ZA 8-21-2019
Item # 5.a.

Fwd: Objection to Variance V18-005/Chellappan - hearing on 8/21/19

Driveway_picture.JPG
107K

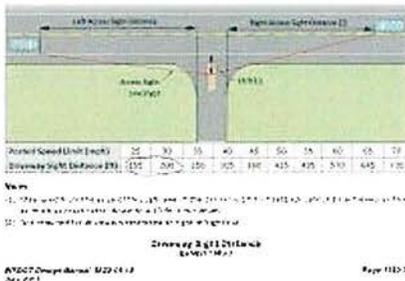
We performed an actual "drive by" test, with the assistance of a Police Chief and a Civil Engineer. We found that coming out from the subdivision the absolute earliest we were able to spot the very top of the roof of a car coming out from the garage location was about 140 ft. away (and that was specifically looking for the very first portion of the car roof, while in reality a driver would not spot that, and would have to see at least a portion of the car before he can react - so it would be less than 140 ft) Given that most cars drive at 25-30 mph, the optimistic 140 ft is significantly below the 155-200 ft required by the WSDOT Design Manual (see attachment for picture and reference)
